Planning Commission Issues Report

Subject: Change of Zoning Issues Report

Petition: P.Z. 12-2013 The Wedge (McGrath Plaza)

RE: Energy Marketing #709 – Preliminary Development Plan/Change in Zoning “Wedge Property”
Pickett, Ray & Silver, Inc. Project No. 09056.EMKT.00R

Preliminary Plan

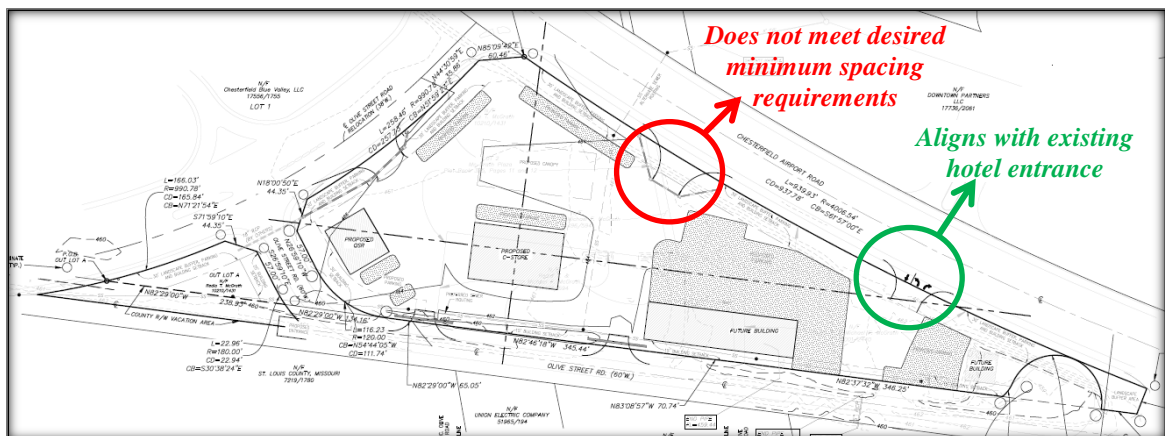
Following the Public Hearing, the Petitioner provided an amended Preliminary Plan which made revisions to the site to address issues identified at the Public Hearing and by Staff. This new Preliminary Plan increased the landscape buffer along Chesterfield Airport Road and the relocated portion of Olive Street Road to the thirty (30) foot minimum requirement for commercial districts with frontage along arterial streets. In order to achieve this, the Petitioner removed the previously proposed fifteen (15) foot landscape buffer along Old Olive Street Road, which is no longer classified as an arterial street and is therefore not subject to any buffering requirement by the Municipal Code. Further, in removing the buffers along Old Olive Street Road, the applicant has pushed the large parking areas back to the property line. The internal circulation area surrounding the proposed fast food restaurant (identified as “Proposed QSR” on the Preliminary Plan) was modified to incorporate the thirty (30) foot landscape buffer and the proposed building now abuts the buffer area. The proposed entrance located off of the cul de sac at the eastern end of the site has been removed. No revisions were made to the five proposed access points off of Chesterfield Airport Road, relocated Olive Street Road, and Old Olive Street Road. As previously advised, the access points do not meet City Code requirements and will create conflicts and safety issues if permitted.

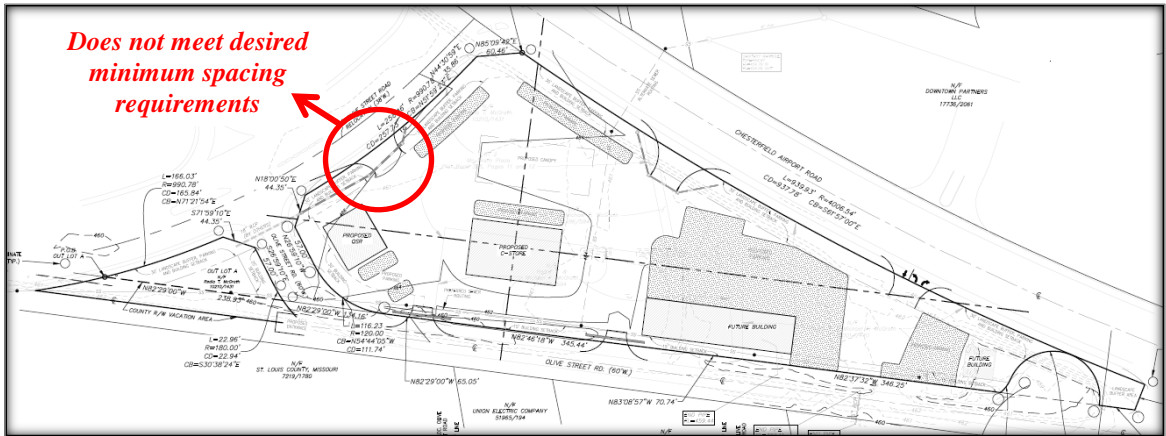
In their November 26, 2013 correspondence, the Petitioner indicates compliance with the drive spacing requirements; however, Staff does not agree that compliance has been achieved. The proposed driveway locations on Chesterfield Airport Road and Relocated Olive Street Road, as shown on the preliminary plan, do not meet the City’s access requirements as defined in Chapter 26, article III, section 26-55 of the Chesterfield City Code. The proposed development is not located in an older development and the site contains sufficient frontage, therefore, the desired minimum spacing requirements must be met. The desired minimum spacing requirements which the Petitioner is to meet are defined in Table A1 and Table A2 under the section indicated above. The access points shown on the Preliminary Plan do not meet the City’s access requirements in the following ways:

1. Chesterfield Airport Road and Olive Street Road are classified as Major Arterials; as such the requirements are 400 feet for opposite right (downstream) drive spacing, Table A1, and 350 feet for adjacent drive spacing, Table A2. The petitioner was informed of these requirements at a meeting on November 25, 2013.

2. The proposed entrances on Chesterfield Airport Road do not meet the 350 foot spacing requirement as identified in Table A2 or the 400 foot spacing requirement as identified in Table A1. While the code does allow for a maximum of three non-residential entrances for a property with 950 feet of frontage, the entrances must still meet the desired minimum spacing requirement. As depicted on the Preliminary Plan, the easternmost drive must align with the existing hotel entrance on the north side of Chesterfield Airport Road. With the easternmost drive location being set, the remaining distance between the proposed eastern entrance and relocated Olive Street Road is approximately 620 feet. In order to provide the required 400 foot drive spacing, 700 feet would be necessary to accommodate the proposed westernmost entrance on Chesterfield Airport Road. That being said, the proposed western entrance on Chesterfield Airport Road does not meet the required spacing. **As such, Staff recommends that the westernmost access point be eliminated, as shown below.**

3. The property frontage on the relocated Olive Street Road equates to approximately 360 feet. This frontage is located between the remaining portion of Olive Street Road and Chesterfield Airport Road. This does not provide adequate spacing for the proposed access onto relocated Olive Street Road. The proposed entrance is approximately 165 feet from the remaining portion of Olive Street Road. Since 400 feet is the required minimum spacing, the proposed entrance on relocated Olive Street Road does not meet the required spacing. **As such, Staff recommends this access point be eliminated, as shown below.**

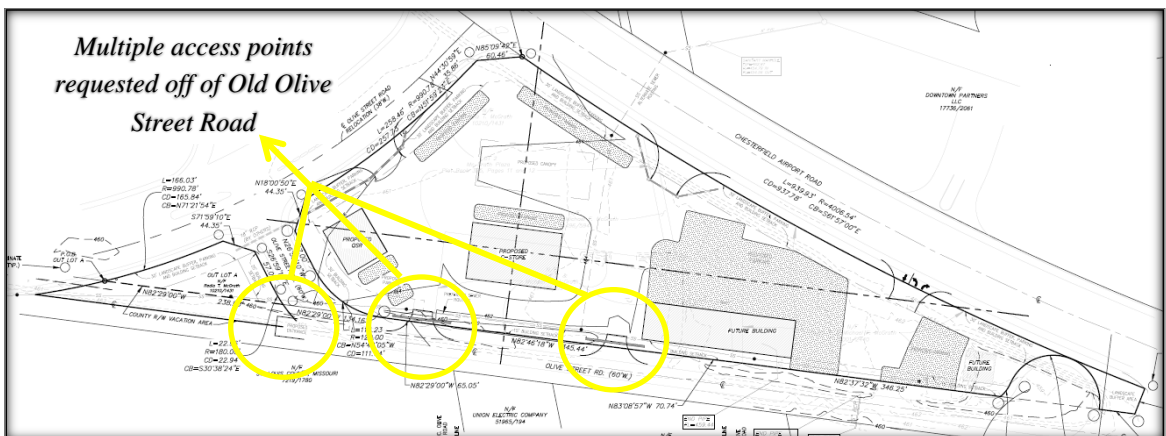
4. The remaining portion of (Old) Olive Street Road has not been reclassified by the City but it would be reasonable to assign it a local street classification. That being said, the two westernmost proposed entrances meet the drive spacing requirements. It is unclear as to purpose of the proposed entrance shown to Outlot A. Clarification as to the purpose of this entrance has not been provided by the petitioner. Although the drive spacing requirements are met, the stated purpose of the City's Driveway Access Location and Design Standards is "to recognize the City's desire to **minimize the number of permitted access points** in an effort to improve traffic flow, minimize congestion, and enhance the public safety. **The number of access points may be restricted, even to the extent that all other criteria may be met.**" Therefore, if the Planning Commission chooses not to request elimination of an access point off of the remaining portion of (Old) Olive Street Road, Staff recommends that a written justification for multiple access points be provided by the Petitioner.

Preliminary Development Plan

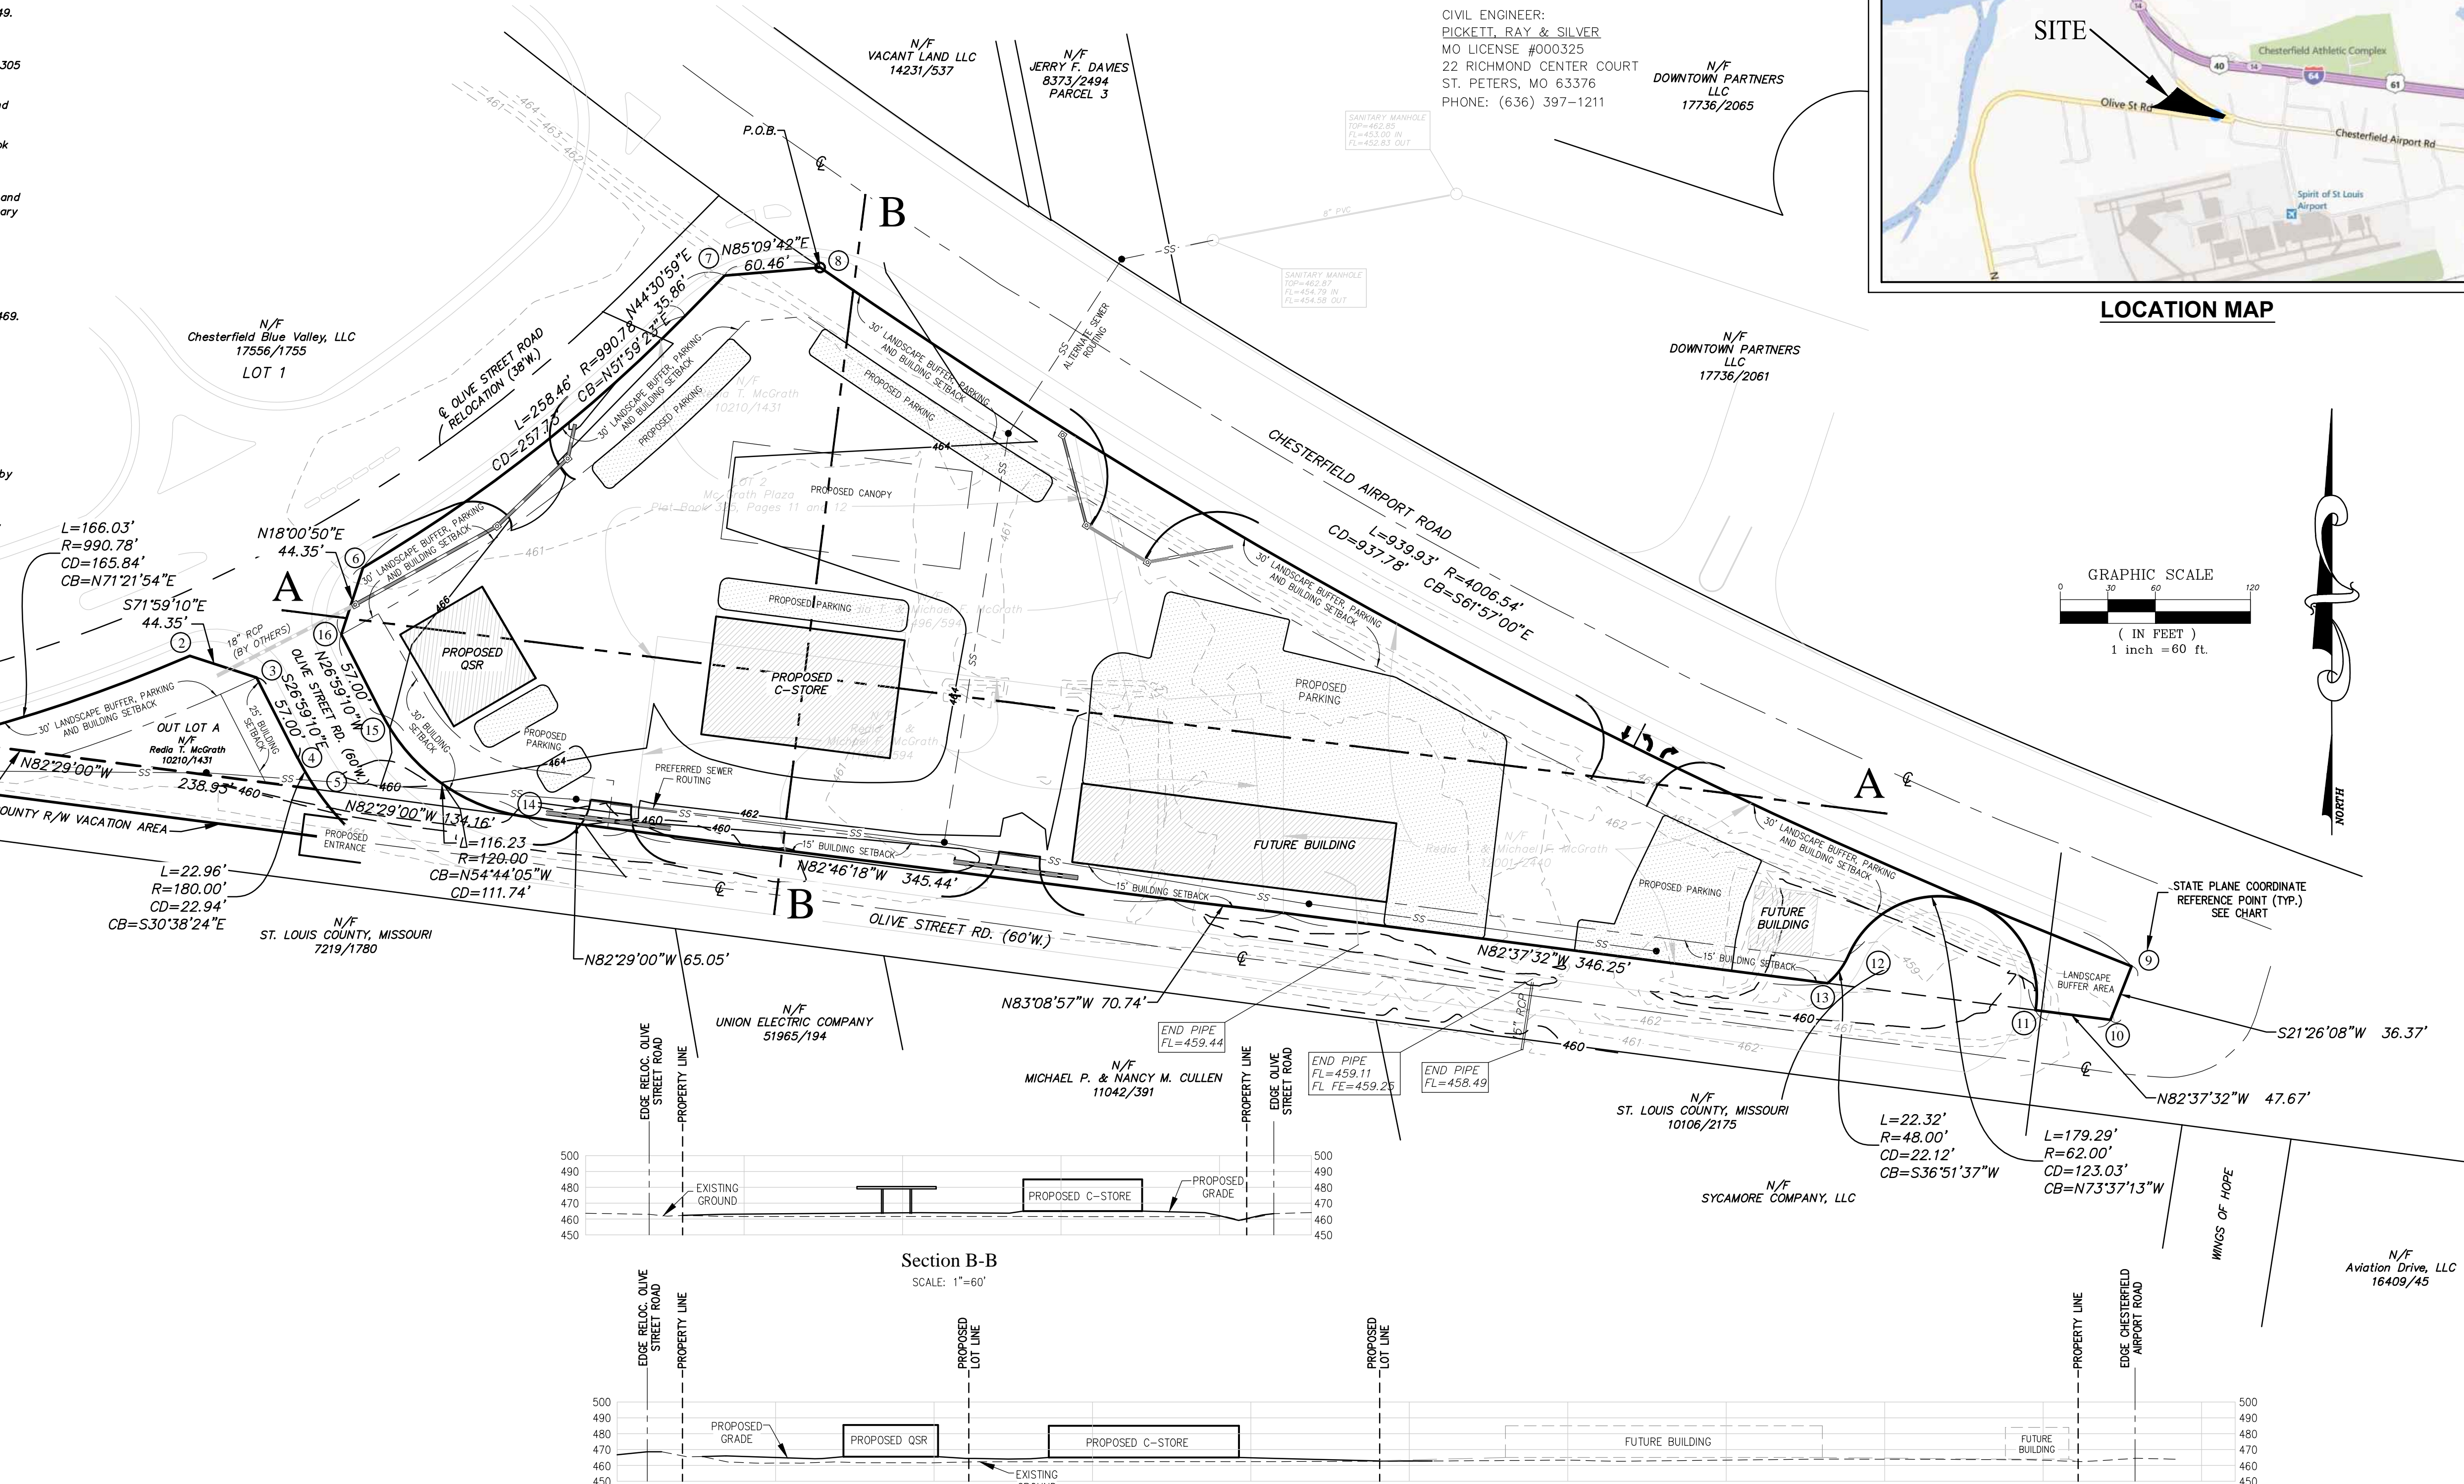
- 1. Address concerns with the number of location and access points off of Olive Street and Chesterfield Airport Roads. Note that compliance with Chapter 25 Article III Driveway Access Location and Design Standards of the Municipal Code is required.*

3. *Address concerns with requested setbacks and lack of landscape buffers as required by Chapter 27.5 Tree Preservation and Landscape Manual of the Municipal Code.*

The drawing has been revised to illustrate that the proposed Development Plan meets the Driveway Access Location and Design Standard of the Municipal Code except at the proposed right-in/right-out on Relocated Olive Street.

- A. Chesterfield Airport Road. Both proposed entrances on Chesterfield Airport Road (Major Arterial) meet the minimum criteria for opposite, Table A-1 (300 feet) and adjacent spacing. Table A-2 (275 feet). The frontage on Chesterfield Airport Road is approximately 950 feet which allows a maximum of three non-residential entrances and we are proposing two entrances. Additionally, the plan meets the geometric design criteria for width and driveway throat length of 80 feet for an arterial as shown on the plan.

- B. Relocated Olive Street Road. The plan proposes one right-in/right-out entrance on Relocated Olive Street located approximately 163 feet from the existing entrance to the dead end portion of Olive Street Road. This right-in/right-out entrance was granted by City of Chesterfield Ordinance No. 811, Bill No. 828 on Page 2 of Attachment A, Section 4 Site Development Plan Design Criteria, Item d. under Access states “Access to this development from Relocated Olive Street Road shall be restricted to one commercial entrance restricted to right-turns in and right-turns out by the raised median on Relocated Olive Street Road. This driveway shall be located and constructed as directed by the St. Louis County Department of Highways and Traffic.”

C. Dead End Portion of Olive Street Road. The plan shows two entrances from the dead end portion of Olive Street Road to the development site. The first entrance is approximately 297 feet from Relocated Olive Street Boulevard and the second entrance is 260 feet further east along the dead end portion of Olive Street Boulevard. These entrances meet the City of Chesterfield criteria for a collector or local street classification. This portion of Olive Street Road has been modified and a cul-de-sac has been constructed at the end of the road near Wings of Hope and should now be classified as a local street. Additionally, the plan meets the geometric design criteria for width and driveway throat length of 45 feet for a non-residential and collector class street.

The plan has been revised to include a 30-foot wide landscape buffer, parking and building setback along the entire portion of Chesterfield Airport Road and Relocated Olive Street Road.
